Addendum No. 1
May 3, 2022

Project: Webster Area School – 2022 CTE Addition & Remodeling
Webster, South Dakota
Architecture Incorporated Project #2936

Scope of this Addendum:

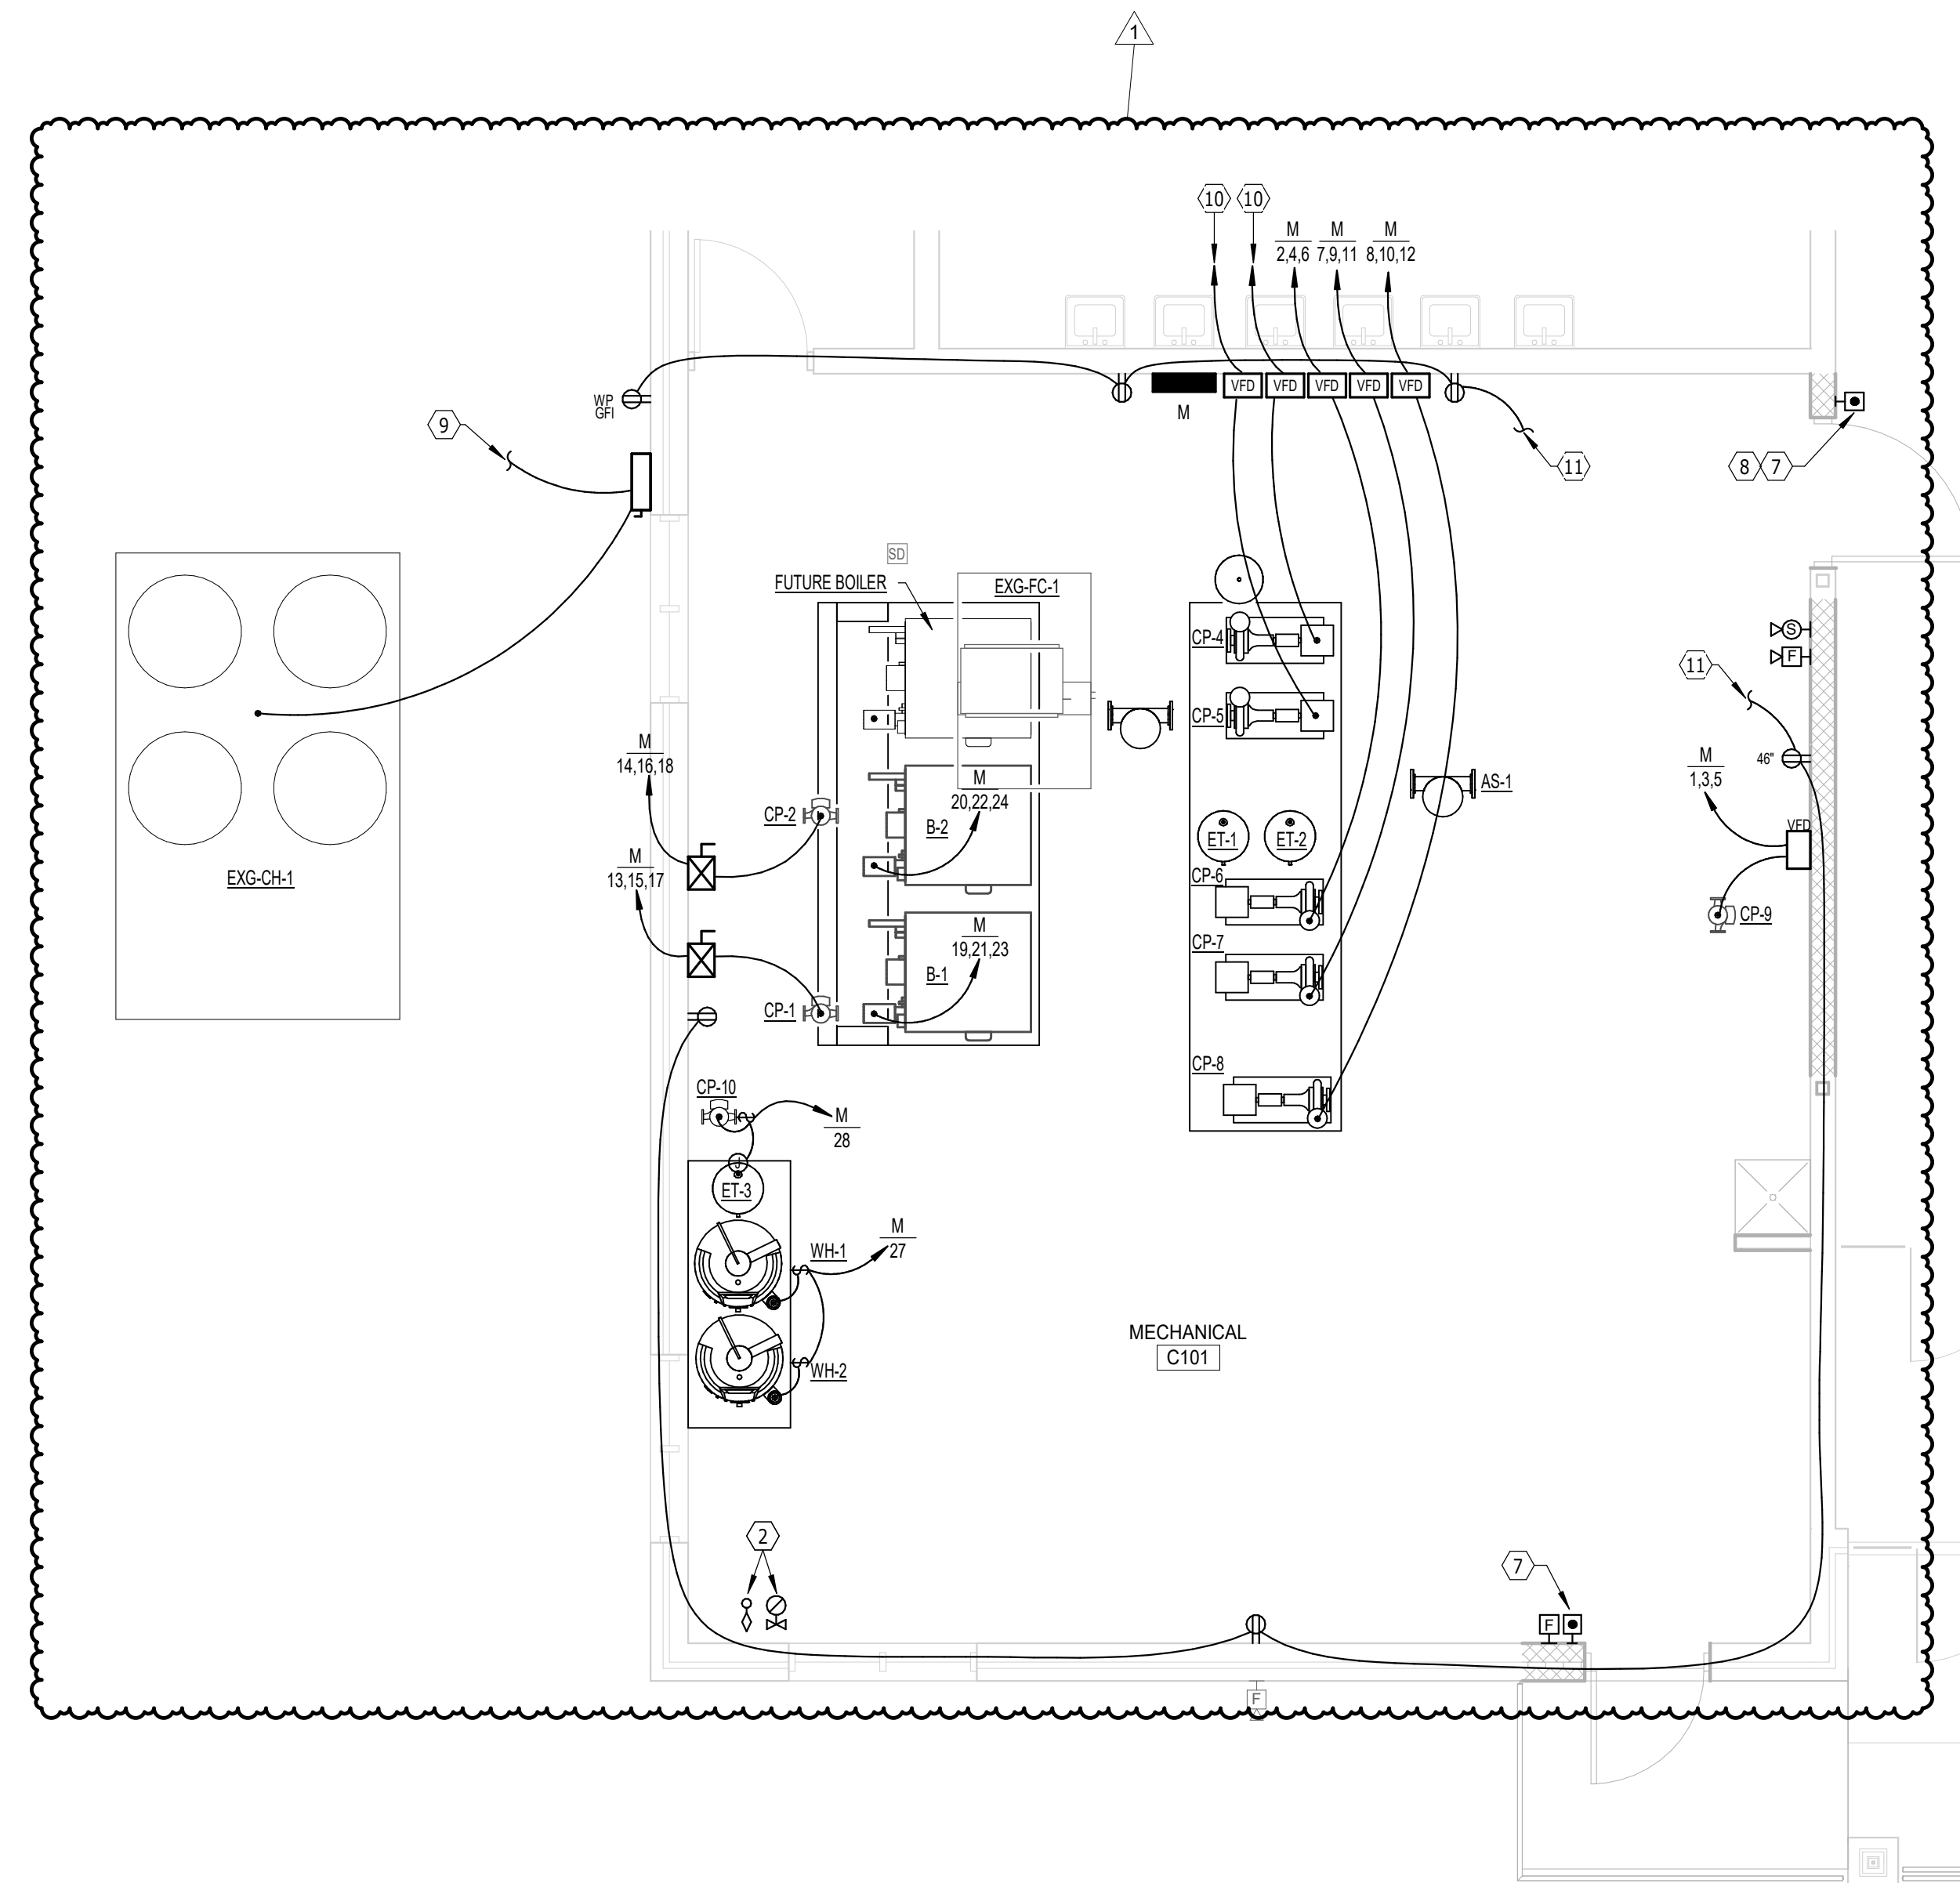
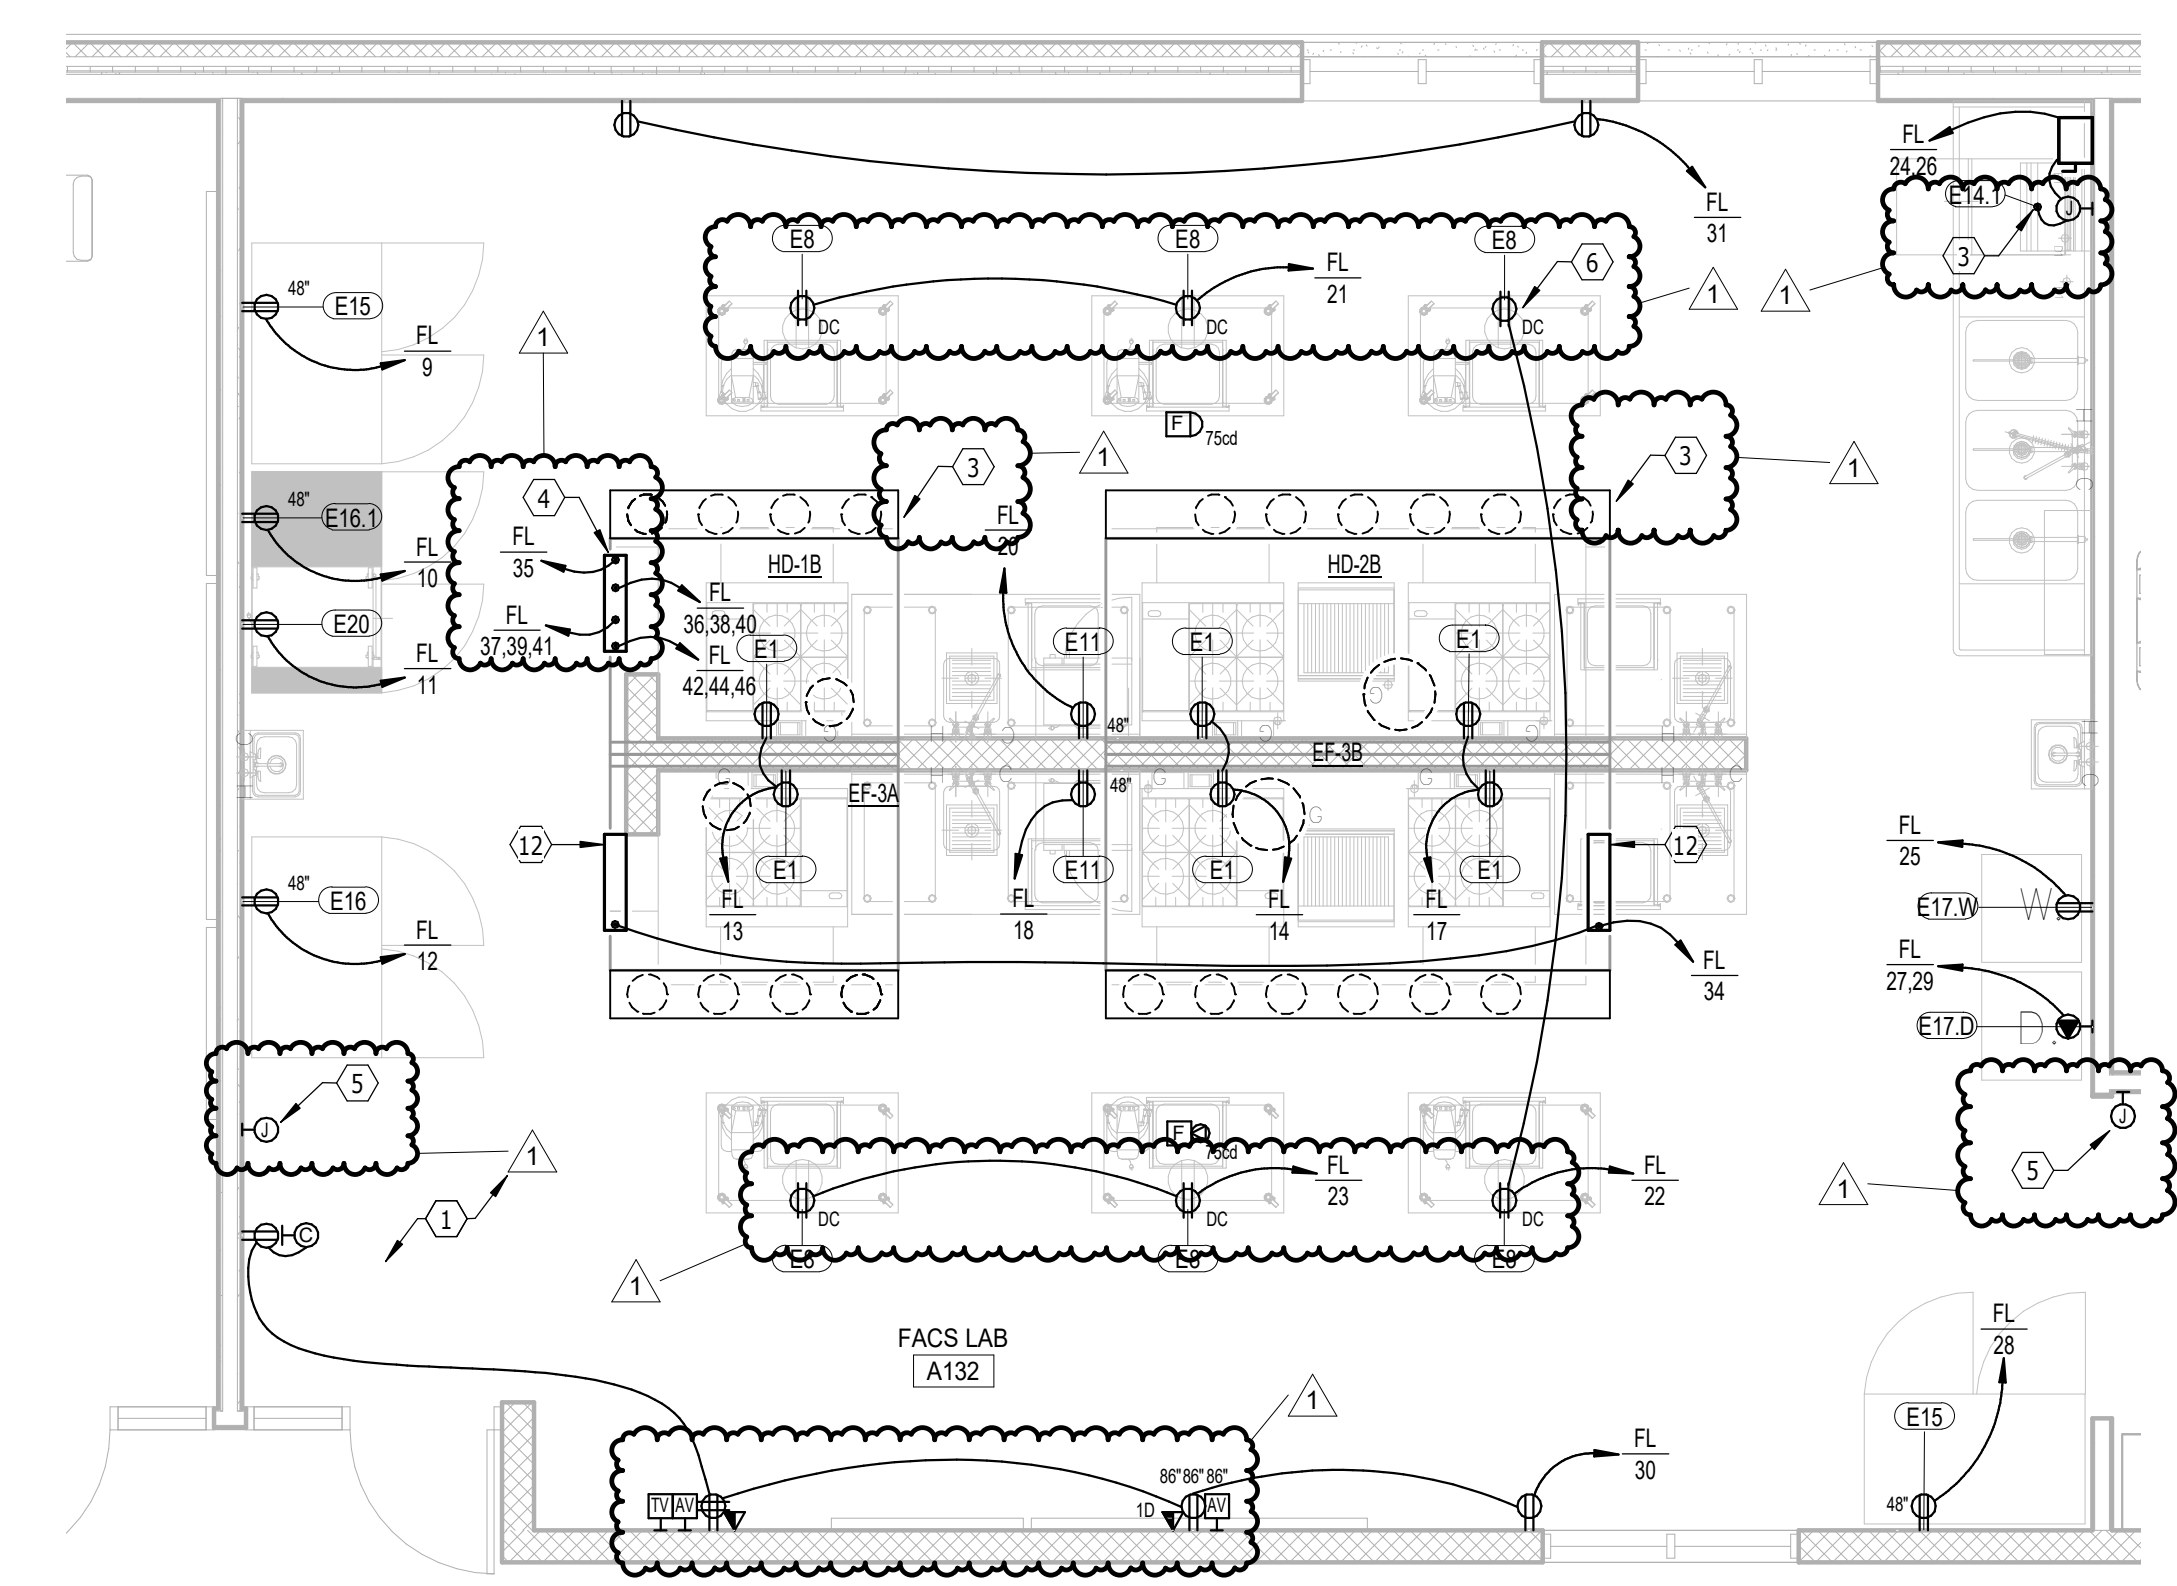
- 9) DRAWING SHEET 9.41 – ENLARGED PLANS – POWER & SIGNAL
 - a) See the attached revision drawing.
- 10) DRAWING SHEET 9.50 – ELECTRICAL SYMBOLS & ABBREVIATIONS
 - a) See the attached revision drawing.
- 11) DRAWING SHEET 9.51 – ELECTRICAL SCHEDULES
 - a) See the attached revision drawing.
- 12) DRAWING SHEET 9.52 – ELECTRICAL SCHEDULES
 - a) See the attached revision drawing.
- 13) DRAWING SHEET 9.53 – ELECTRICAL DETAILS
 - a) Add the detail shown below.
